# V3 - SDP-23-04

7- ELEVEN 9350 CST  
 US 401 BUSINESS / S. MAIN STREET & VIRGINIA WATER DRIVE  
 ROLESVILLE, NC

**Drawing Size:** 30 x 42  
**Project #:** 22050  
**Drawn By:** MBN  
**Checked By:** CCMB  
**Title:** EXTERIOR COLORED ELEVATIONS

**Sheet Number:** A3.3  
**Date:** 04/27/23 **Store #:** 42337

Sheet Number:  
**A3.4**  
 Date: 04/27/23 Store #: 42337

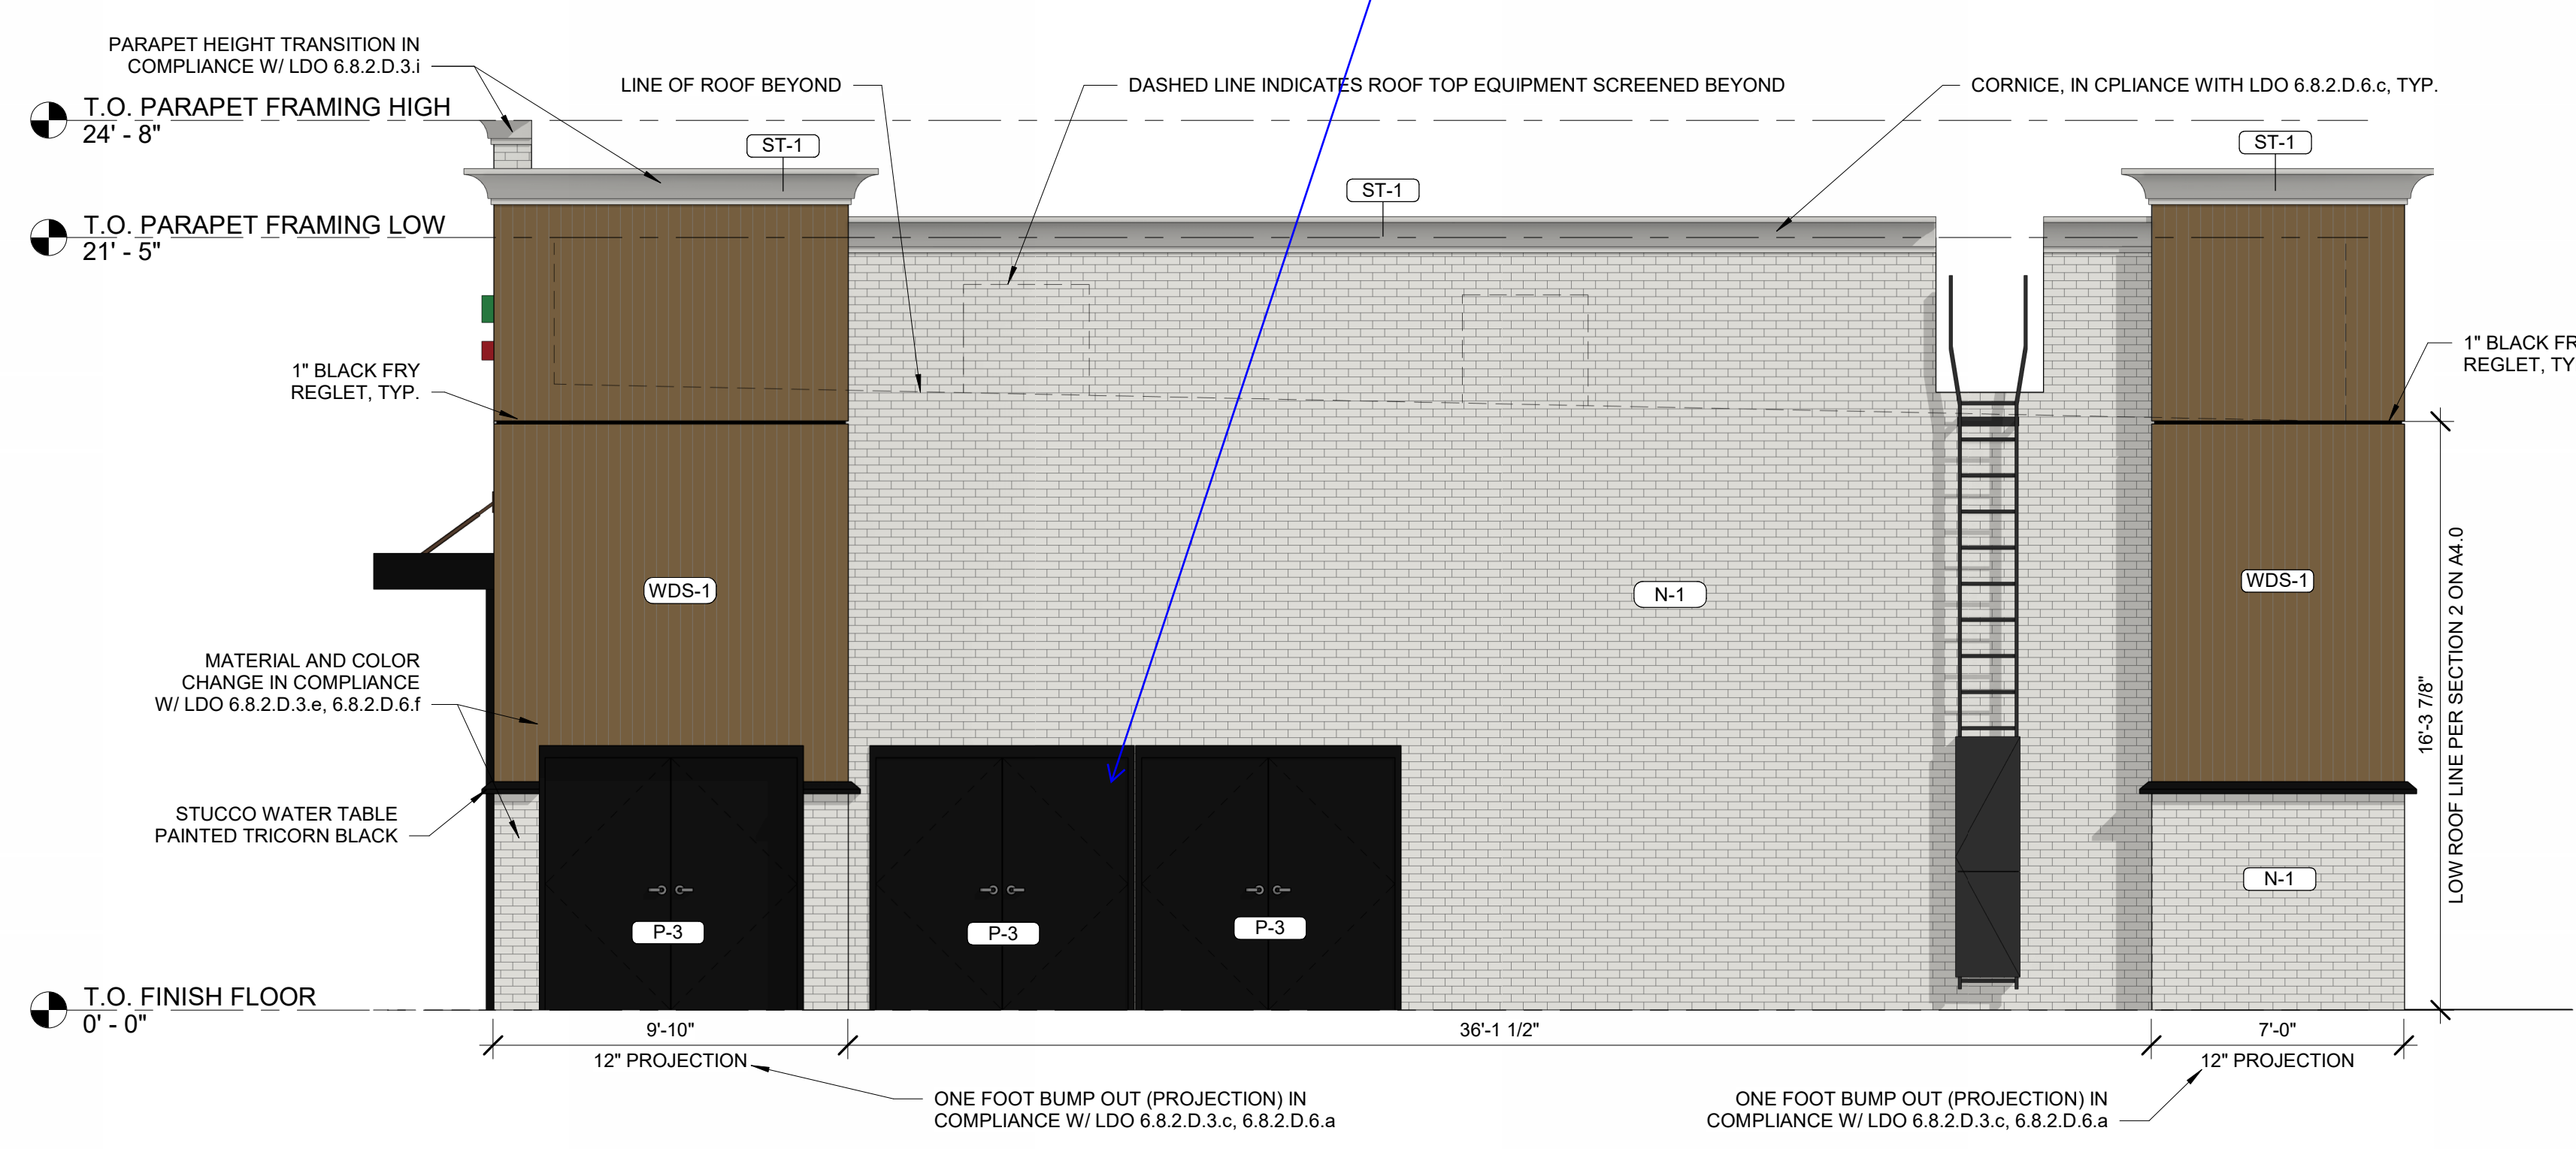
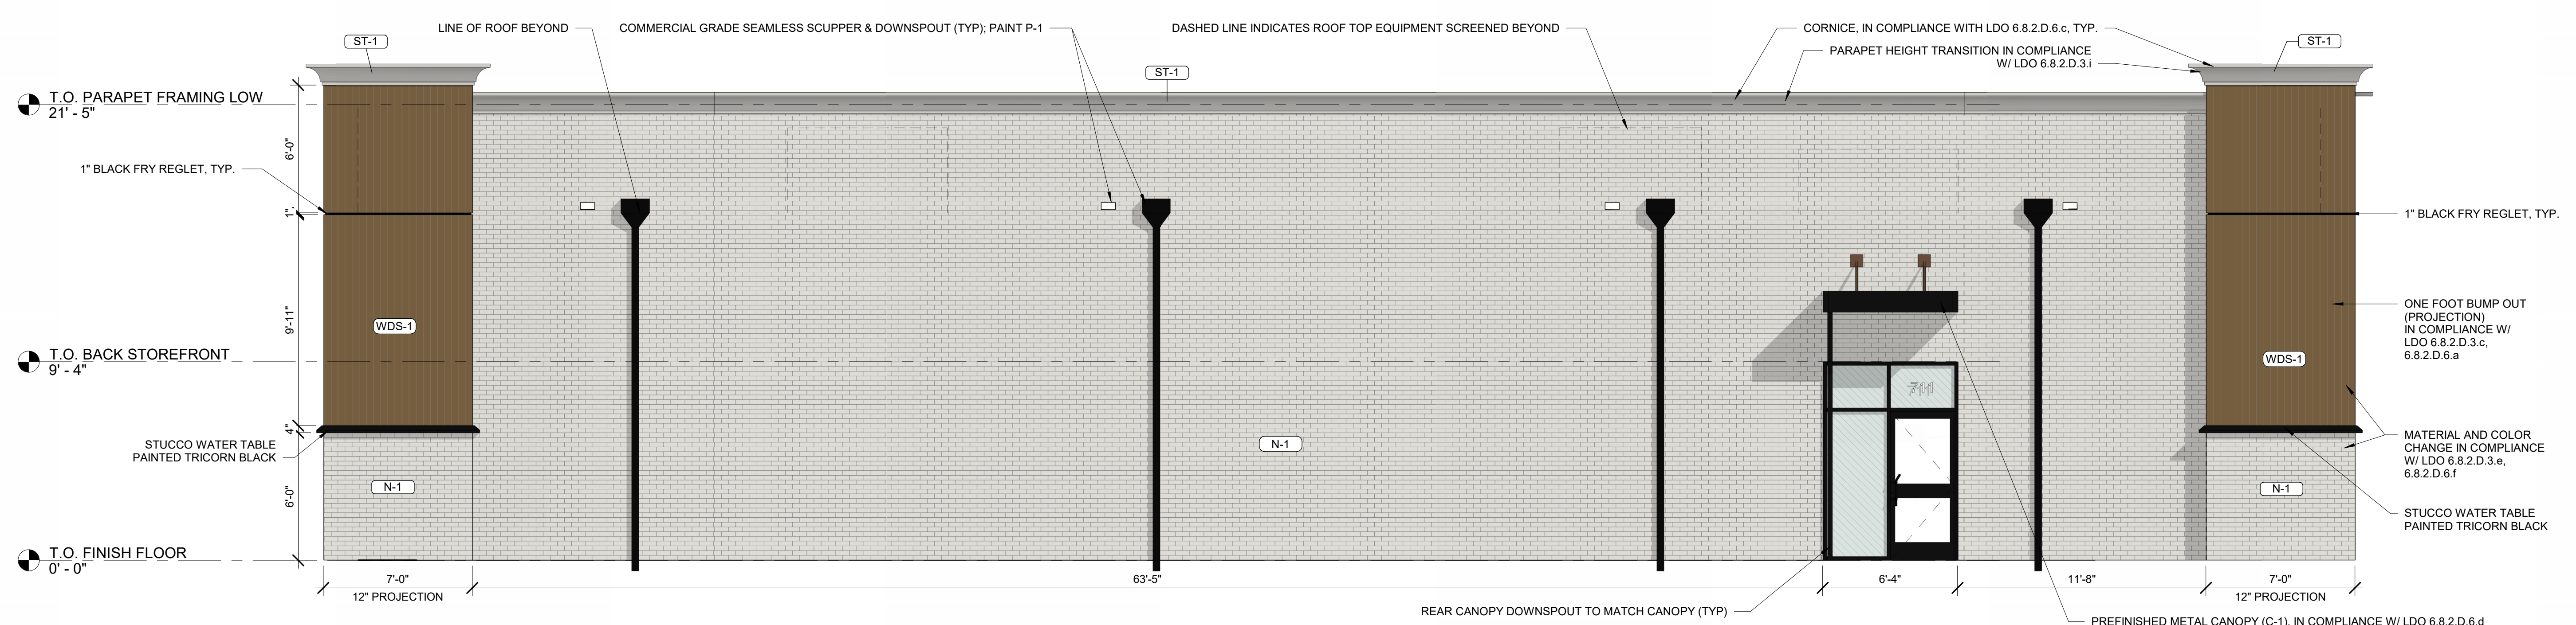
Blank wall area is regulated per LDO Section 6.8.2.C.1. See written comment.

To ensure visually interesting buildings of high-quality visual design, a minimum of four (4) design items noted in LDO Section 6.8.2.D.6 shall be utilized in building design.

The applicant shall demonstrate compliance with the outdoor display and storage in Section 6.2.4.6.C as it appears there are ice coolers and areas for outdoor display of items. If no outdoor storage or display of items is proposed, then a note should be added to the plans.

COMMENT #10: LDO SECTION 6.8.2.B - APPLICABILITY - BUILDING DESIGN STANDARDS SHALL BE REQUIRED ON ALL WALLS OF A BUILDING THAT FACE A PUBLIC STREET OR RIGHT-OF-WAY. THIS SECTION THUS APPLIES TO THE WALLS OF THE PROPOSED BUILDING FACING MAIN STREET AND VIRGINIA WATER DRIVE ONLY.

A. 6.8.2.D.3.A - PAINT IS NOT CONSIDERED A SUBSTANTIAL MATERIAL CHANGE.  
 B. 6.8.2.D.3.C - THE MAXIMUM CONTINUOUS BLANK WALL AREA FOR ANY BUILDING SHALL BE A MAXIMUM FIFTY (50) SQUARE FEET WITHOUT A BREAK BY WINDOWS, DOORS, ARCHITECTURAL FEATURES GREATER THAN ONE (1) FOOT IN DEPTH, OR A SUBSTANTIAL MATERIAL CHANGE, UNLESS EXPLICITLY STATED ELSEWHERE IN THIS LDO.

C. SEE MARK-UP - REVISE DRAWING TO PROVIDE DIMENSIONS THAT SHOW/PROVE EITHER THERE ARE NO BLANK WALL AREAS, OR REVISE DRAWINGS TO BREAK UP THE TECHNICALLY BLANK WALL AREAS.

D. NOTE: IF THESE BLANK WALL AREAS ARE THE INTENDED LOCATIONS OF (FUTURE) SIGNS, DRAW IN 'BOXES' FOR 'FUTURE SIGN HERE' AND EXPLAIN IF/THAT THOSE SIGNS WILL BE DIMENSIONAL AND MEET THE INTENTS OF THE ARCHITECTURAL MEANS TO BREAK UP A BLANK WALL AREA, BUT WITH SIGNAGE RATHER THAN ARCHITECTURE.

D. ACKNOWLEDGED.  
 COMMENT #12: LDO SECTION 6.8.2.D.2 - REVISE SHEET A3.3 TO DEMONSTRATE COMPLIANCE. GROUND FLOOR TRANSPARENCY SHALL BE CALCULATED BASED ON THE TOTAL FAÇADE AREA LOCATED BETWEEN THE FINISH GROUND FLOOR LEVEL AND BEGINNING OF THE UPPER FLOOR. ALL GROUND FLOOR TRANSPARENCY SHALL BE A MINIMUM THIRTY (30) PERCENT, UNLESS STATED OTHERWISE IN THIS LDO.

COMMENT #13: LDO SECTION 6.8.2.D.6 - REVISE SHEET A3.3 TO PROVIDE/SHOW MINIMUM OF FOUR (4) DESIGN ITEMS NOTED IN THIS SECTION TO ENSURE VISUALLY INTERESTING BUILDINGS OF HIGH-QUALITY VISUAL DESIGN.

Blank wall areas have been revised. Please see updated elevations and comment responses on this sheet.

A minimum of 4 design items have been incorporated. Please see updated elevations and comment responses on this sheet.

These are doors to the electrical room, not outdoor storage.

RESPONSE: ACKNOWLEDGED. SEE UPDATED EXTERIOR ELEVATIONS FACING MAIN STREET AND VIRGINIA WATER DRIVE.  
 COMMENT #11: LDO SECTION 6.8.2.C.1 AND 6.8.2.D.3 - BLANK WALL AREA - DEFINED AS "BLANK WALL AREAS ARE PORTIONS OF AN EXTERIOR FAÇADE THAT DOES NOT INCLUDE WINDOWS, DOORS, COLUMNS, PILASTERS, ARCHITECTURAL FEATURES GREATER THAN ONE (1) FOOT IN DEPTH, OR A SUBSTANTIAL MATERIAL CHANGE."

RESPONSE: ACKNOWLEDGED. SEE UPDATED EXTERIOR ELEVATIONS FOR COMPLIANCE TO LDO SECTION 6.8.2.C.1 AND 6.8.2.D.3. ONE FOOT DEEP BUMP OUTS WERE ADDED TO ALL FOUR CORNER OF THE BUILDING TO ELIMINATE THE BLANK WALL AREAS AND ADD HORIZONTAL AND VERTICAL BREAKS.

A. ACKNOWLEDGED. SEE EXTERIOR ELEVATIONS FOR COMPLIANCE WITH LDO SECTION 6.8.2.D.3.A THAT DEMONSTRATE MATERIAL CHANGES AS REQUIRED.  
 B. SEE UPDATED EXTERIOR ELEVATIONS FOR COMPLIANCE WITH LDO SECTION 6.8.2.D.3.C. THE FOLLOWING DESIGN ITEMS HAVE BEEN ADDED TO COMPLY WITH 6.8.2.D.6 LETTERS A, C, D, E, F, G, AND I. BUMP OUTS, CHANGES IN HEIGHT OF THE WALL, MATERIAL CHANGES, AWNINGS, CORNICES AND ALCOVES.

C. SEE UPDATED EXTERIOR ELEVATIONS FOR REVISED DEPTH CHANGES AND HORIZONTAL AND VERTICAL BREAKS. DIMENSIONS HAVE BEEN PROVIDED FOR MINIMUM ONE FOOT DEPTH CHANGE.

RESPONSE: SHEET A3.3 AND A3.4 HAS BEEN UPDATED TO INCLUDE TRANSPARENCY INFORMATION CONCERNING THE ELEVATION FACING MAIN STREET AND VIRGINIA WATER DRIVE, IN ACCORDANCE WITH LDO SECTION 6.8.2.D.2. THE TRANSPARENCY HAS A MINIMUM OF 30%.

RESPONSE: SEE SHEET A3.3 AND A3.4 FOR CHANGES MADE IN ACCORDANCE WITH LDO SECTION 6.8.2.D.6. THE FOLLOWING DESIGN ITEMS HAVE BEEN ADDED TO COMPLY WITH 6.8.2.D.6 LETTERS A, C, D, E, F, G, AND I. BUMP OUTS, CHANGES IN HEIGHT OF MATERIAL, MATERIAL CHANGES, AWNINGS, CORNICES, AND ALCOVES.

1 SITE PHOTOMETRICS  
E0.2 N.T.S.

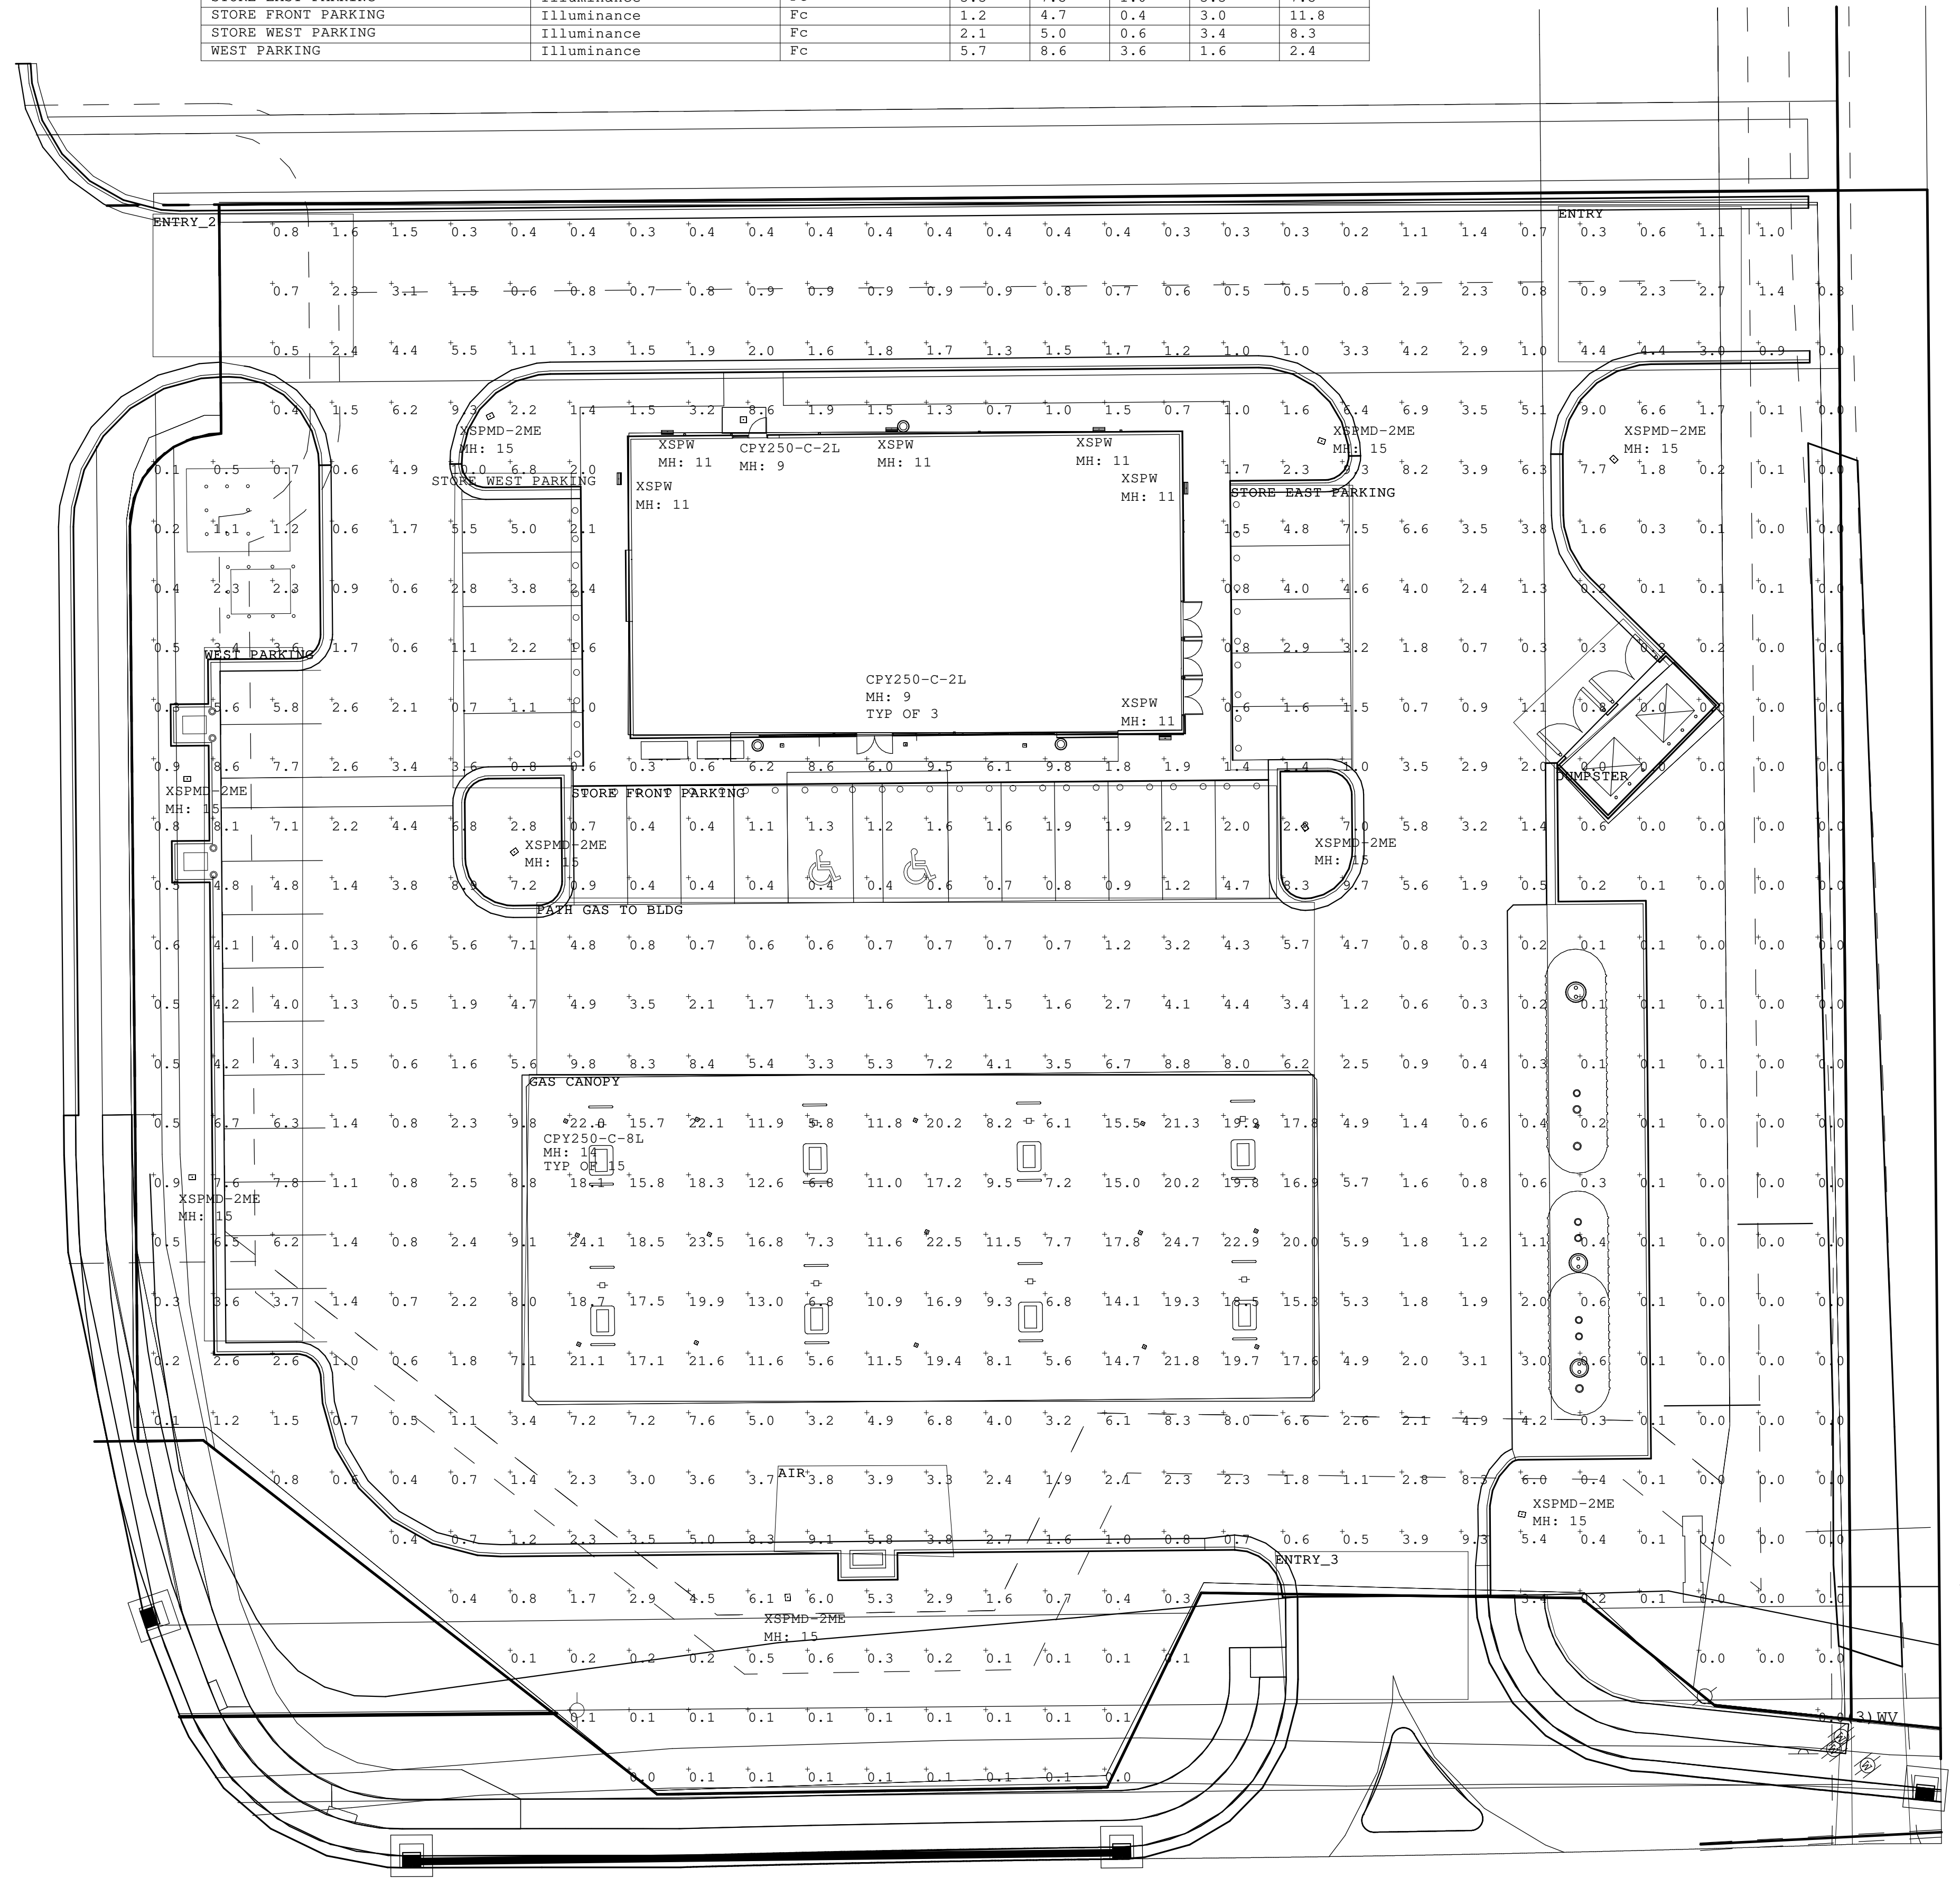
Please refer to the memo for the full list of lighting plan comments.  
Please refer to LDO Section 6.6.G.1-15 for the lighting design standards.  
Please refer to LDO Section 6.6.M for the Gas Station Lighting design standards.

Lighting plan has been revised to be compliant. Lighting fixture details have been added to sheets E0.3 and E0.4.
